**PLEASANT PRAIRIE PLAN COMMISSION MEETING  
VILLAGE HALL AUDITORIUM  
9915 39<sup>th</sup> AVENUE  
PLEASANT PRAIRIE, WISCONSIN  
6:00 P.M.  
JULY 13, 2015**

**PLEASANT PRAIRIE PLAN COMMISSION MEETING  
VILLAGE HALL AUDITORIUM  
9915 39TH AVENUE  
PLEASANT PRAIRIE, WISCONSIN  
6:00 P.M.  
June 8, 2015**

**5 ONSITE "PRIVATE" CONCRETE SIDEWALK (TYPICAL SECTION)**  
NOT TO SCALE

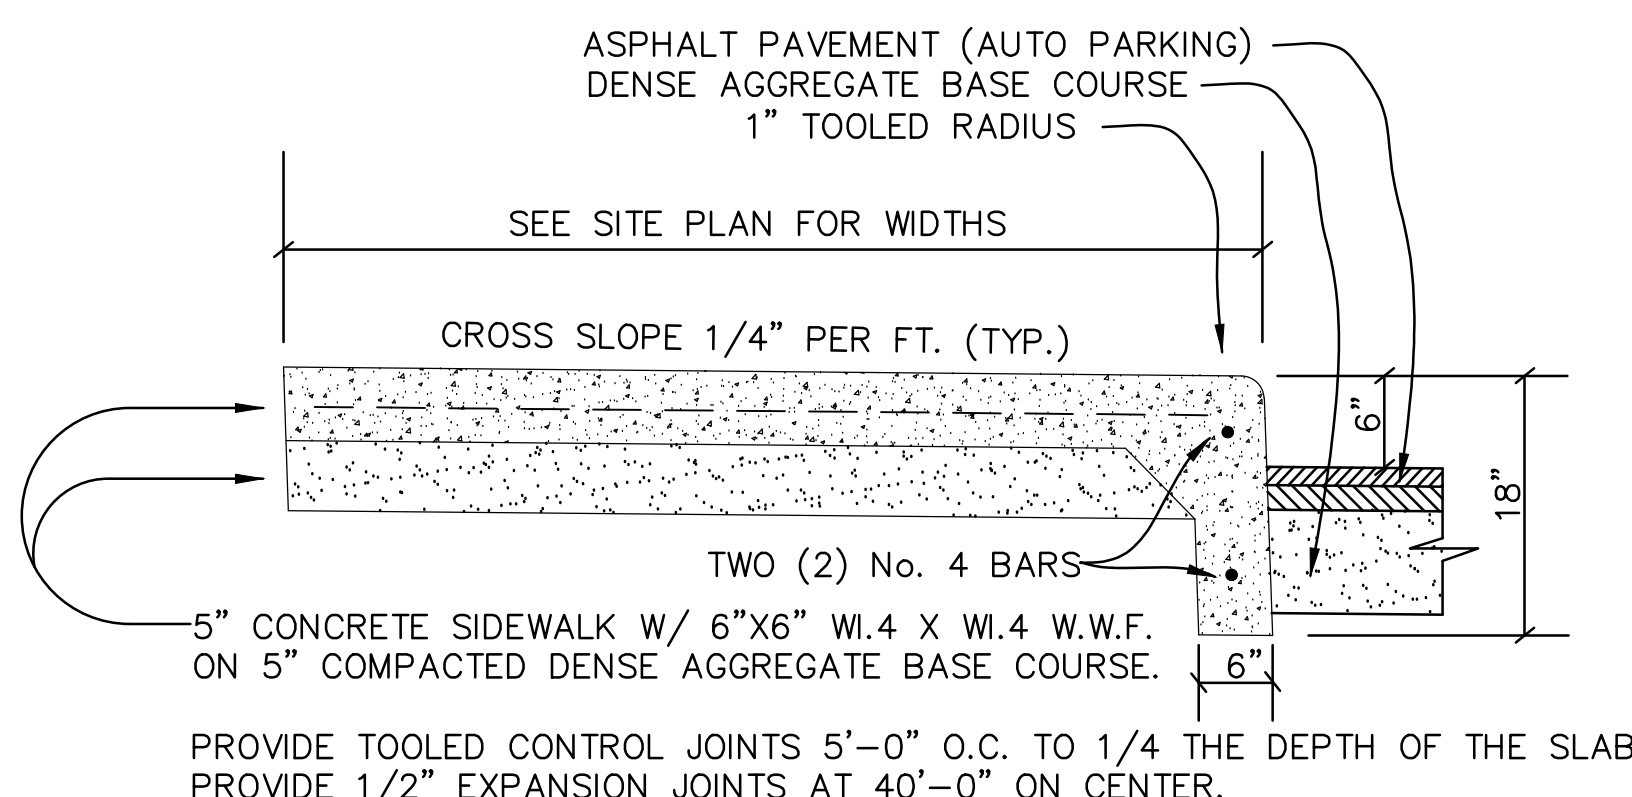
- p. On the Typical Sections and Construction Details (Sheet C-11):
    - i. Sidewalk detail 5 shows a base thickness of 4" which does not match the specified thickness on sheet C-5.

- iii. Revise the sidewalk in detail 6 to be a maximum slope of 2.00%.
  - q. On the Typical Sections and Construction Details (Sheet C-12):
    - i. Update the catch basin detail to match the project specifications.

**7 8" CONCRETE PAVEMENT SHALL INCLUDE 6"X6" W2.9 X W2.9 W.W.F. TRASH ENCLOSURE / APRON CONCRETE PAVEMENT SECTION**  
NOT TO SCALE

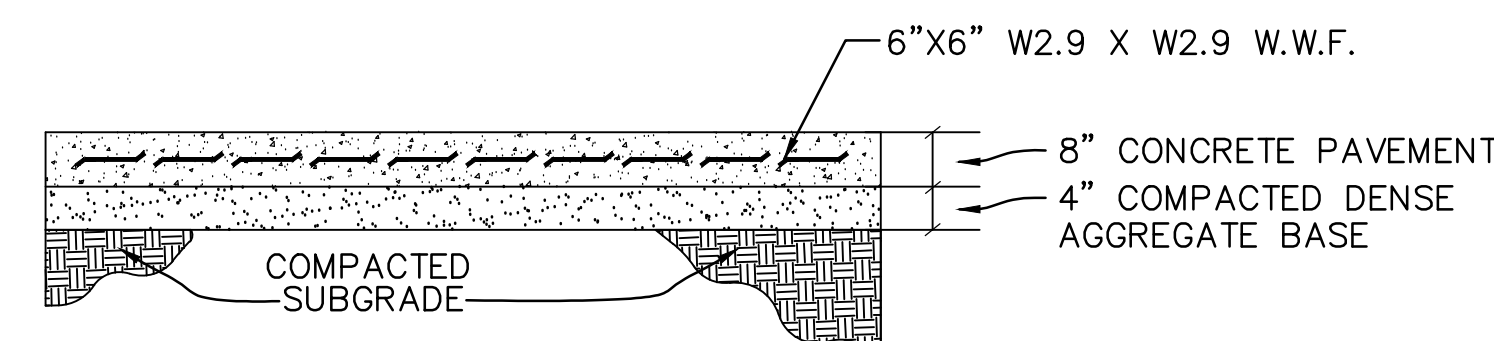
- ii. Trash Enclosure detail 7 shows a base thickness of 4" which does not match the specified thickness on sheet C-5. Provide size, materials, height and other details for the trash enclosures.

**FLOOR PLAN**

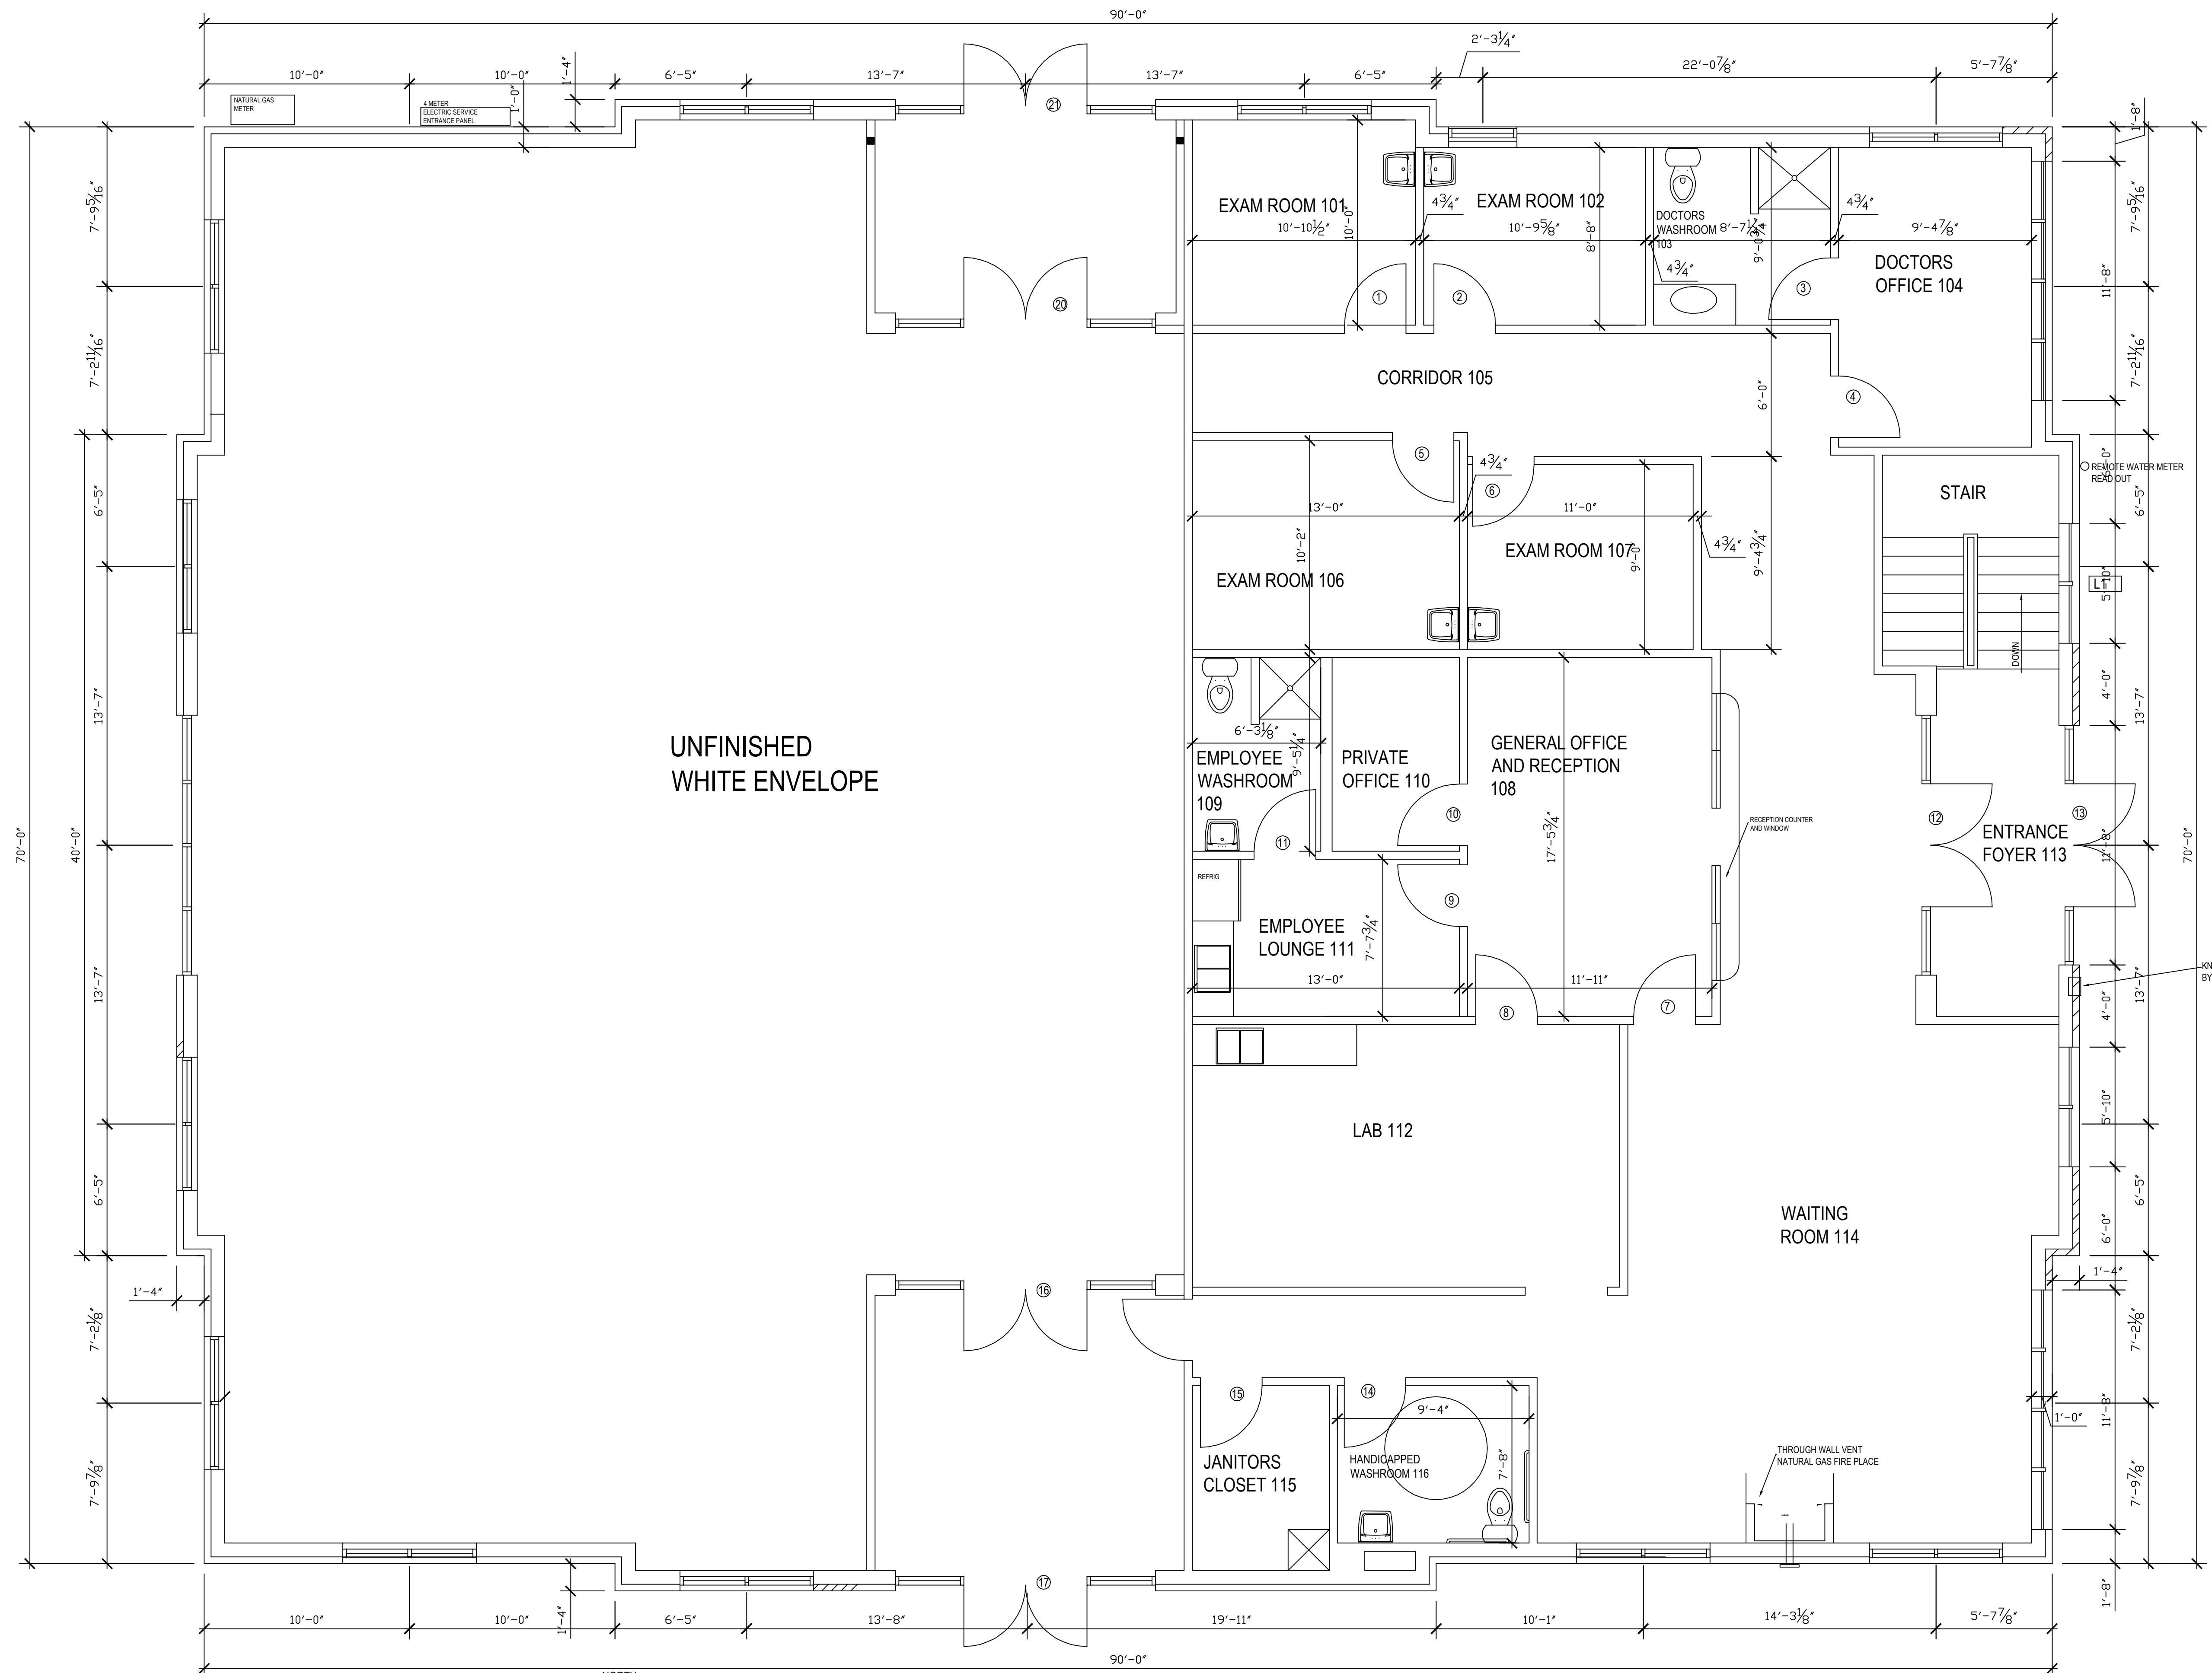
- d. Sheet A4 - Should there be a door installed to the Lab Room (Lab 112)? No door is shown.
- e. Sheet A4 – As a suggestion, with the east side of the building being designated as a medical office use, may want to consider adding an additional restroom along Corridor 105 for patient use.
